## Chrysler Changes Charging Circuit Design From "A" Circuit to "B" Circuit

Figure 1- "A" Circuit

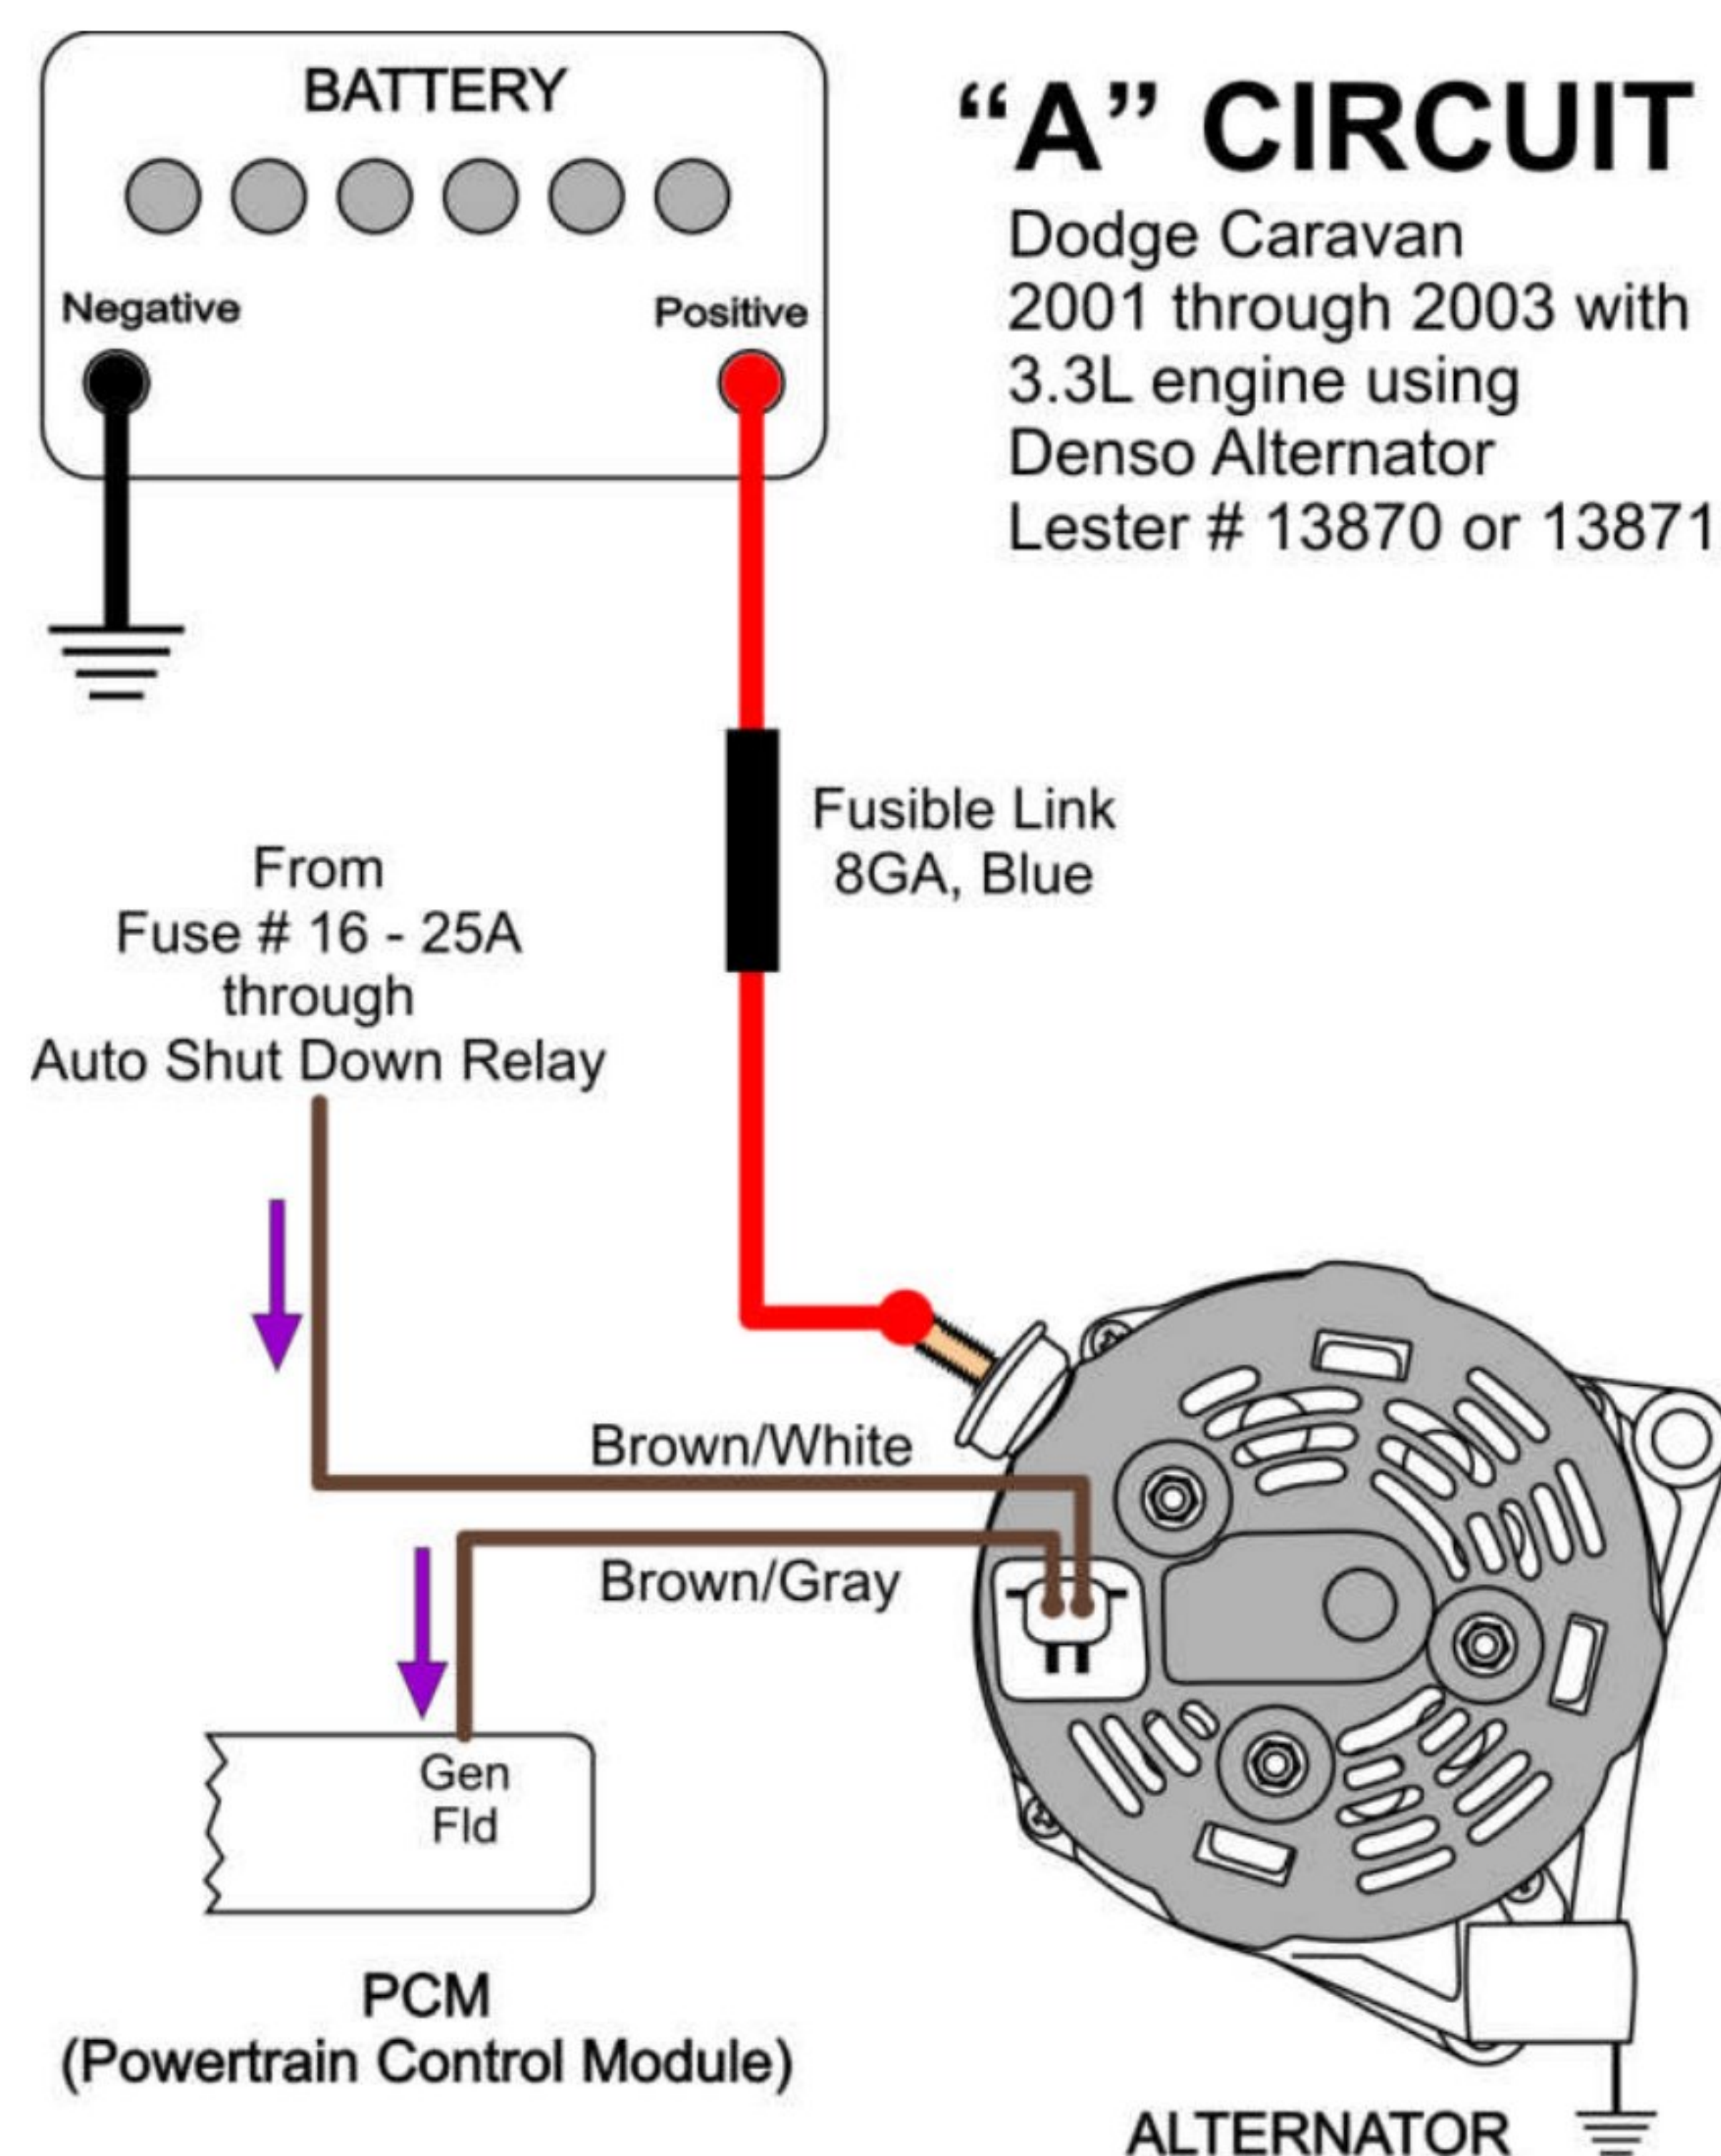
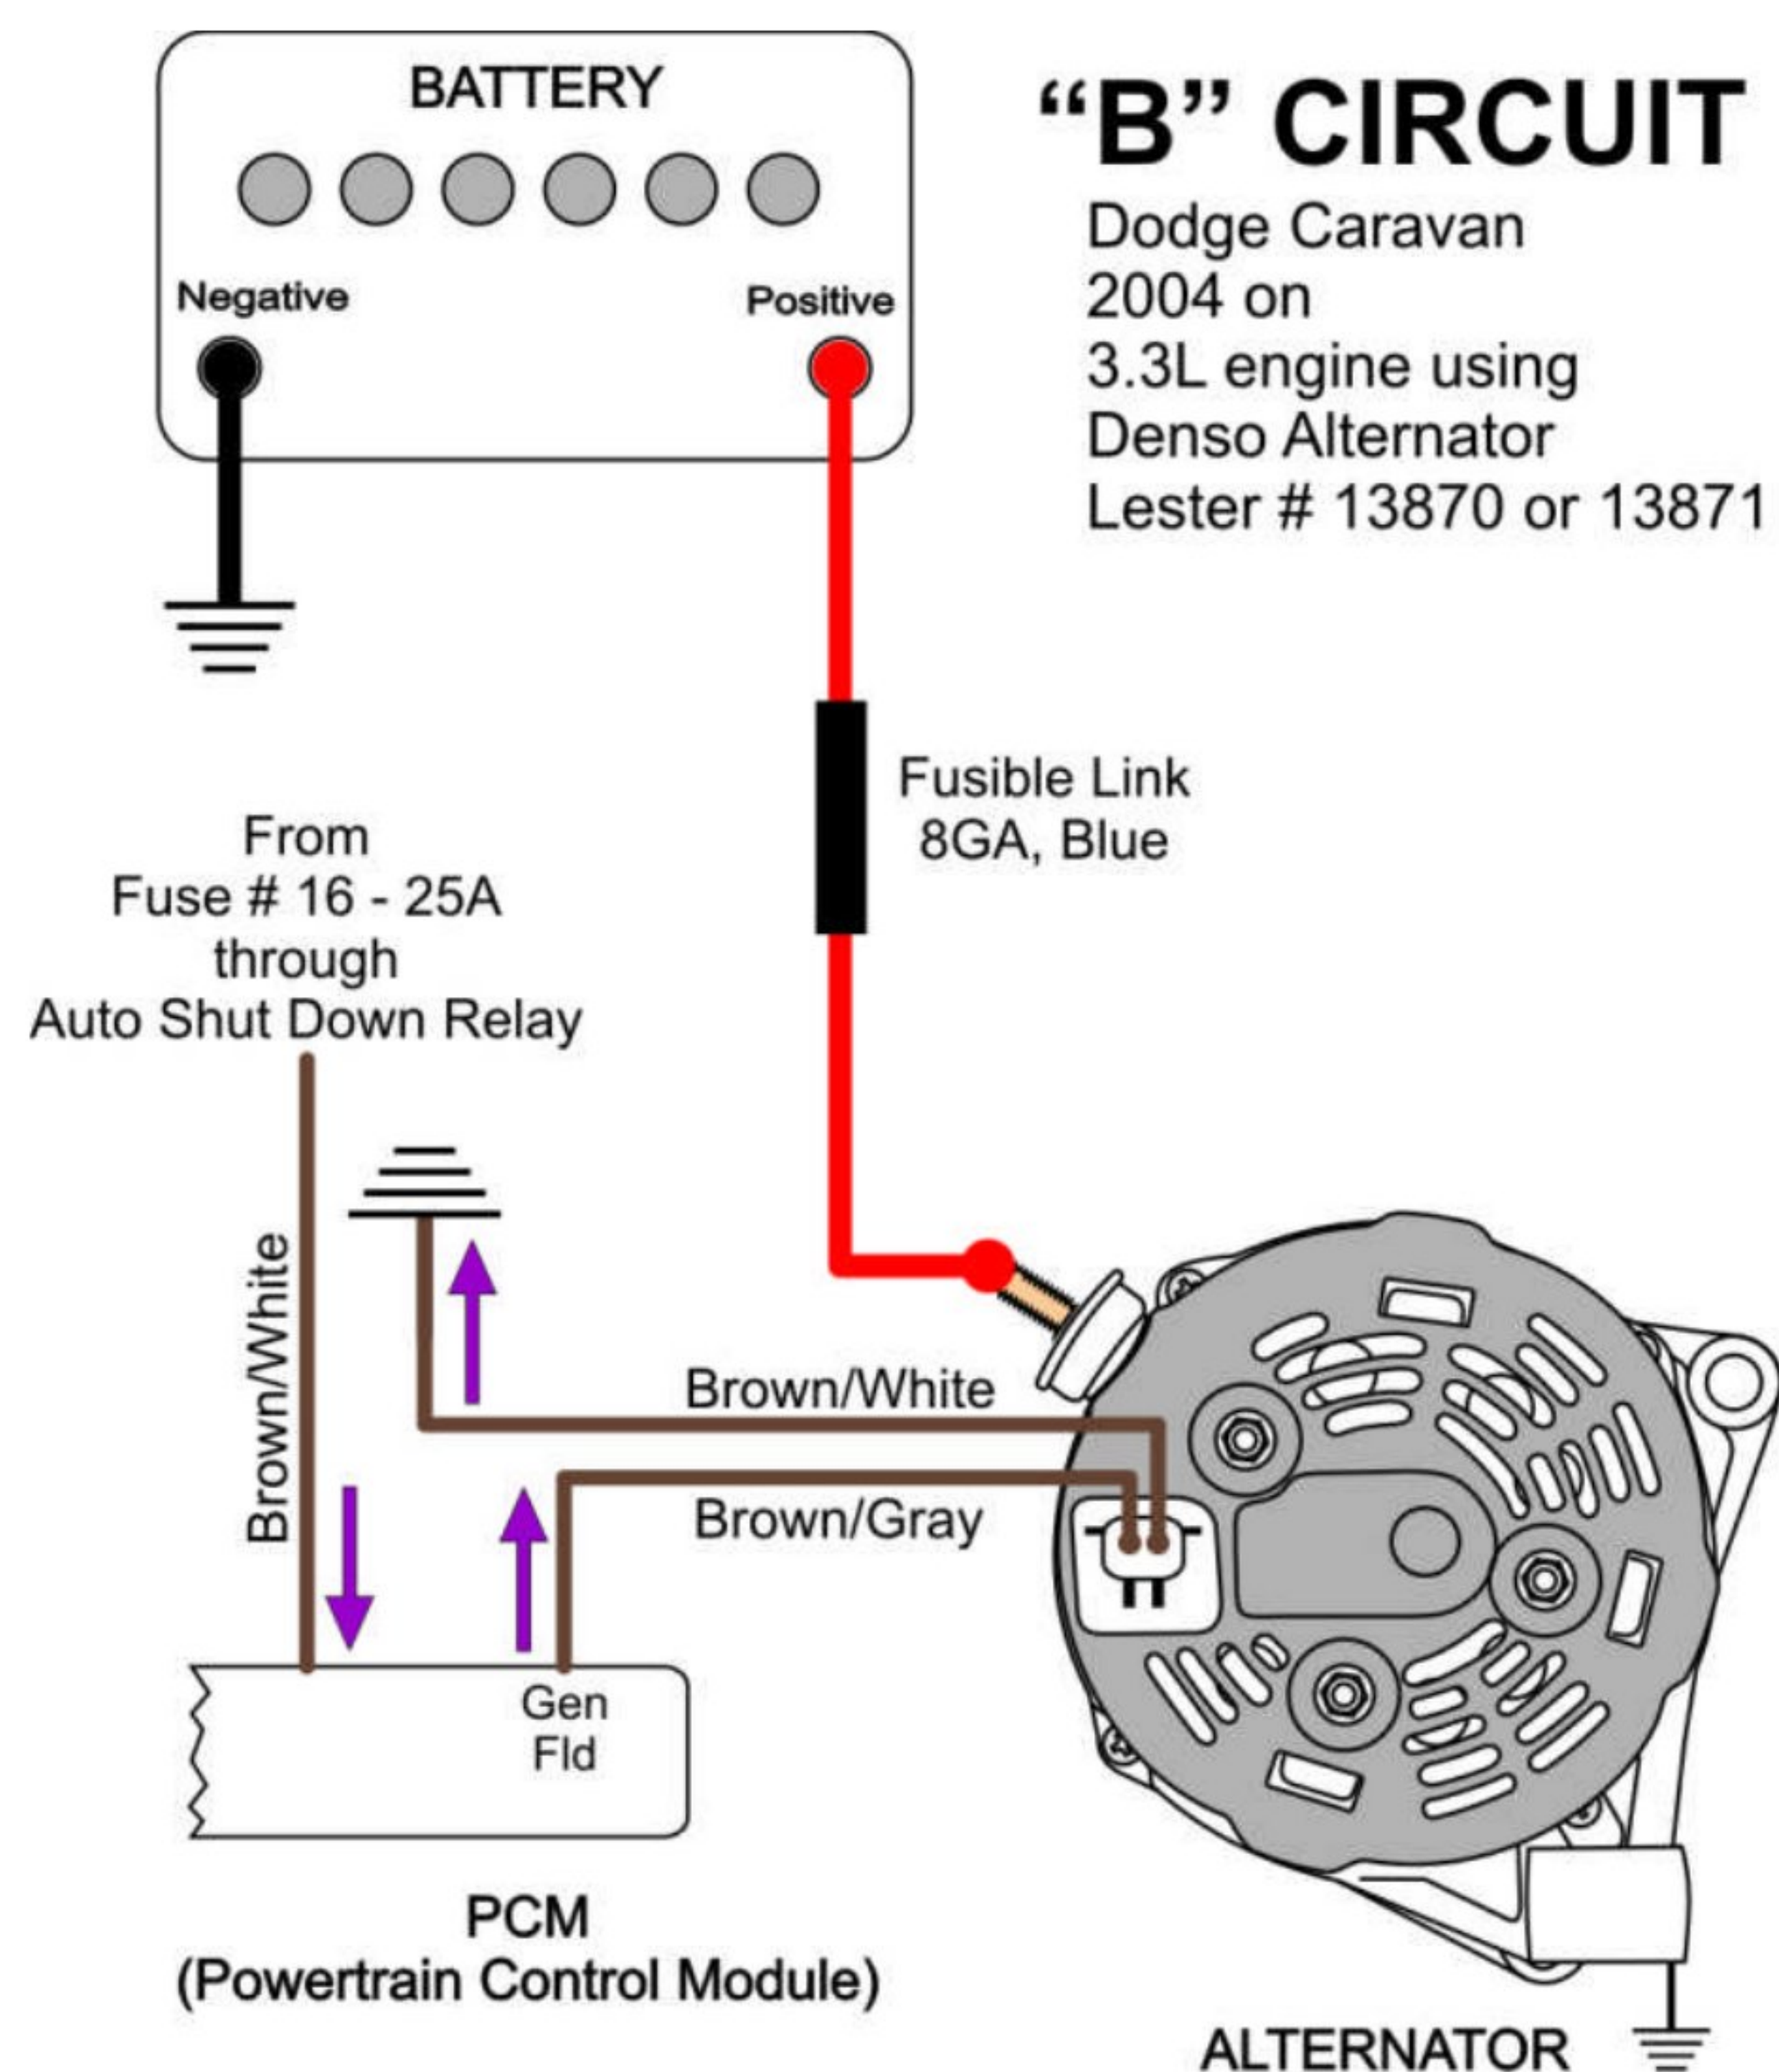
Now, after all these years, Chrysler has changed from "A" circuit to "B" circuit charging systems.

Figure 1 shows the old-style "A" circuit. The arrows show the direction of current-flow through the alternator rotor. Current flows directly from the auto-shut-down relay, through the rotor, to the PCM.

In Figure 2, you can see that in the "B" circuit system, current-flow has been reversed through the alternator rotor. Current flows from the auto-shut-down relay directly to the PCM. The PCM directs the current to the rotor. When the current exits the rotor, it goes to ground via the brown/white wire.

To correctly diagnose Chrysler charging problems, you have to identify the charging system. Chrysler did not change all vehicles at the same time. For example, a 2003 Caravan with the 2.4L engine is a "B" circuit, while a 2003 Caravan with the 3.3L or 3.8L engine is an "A" circuit. Always refer to a wiring diagram for the specific vehicle on which you are working.
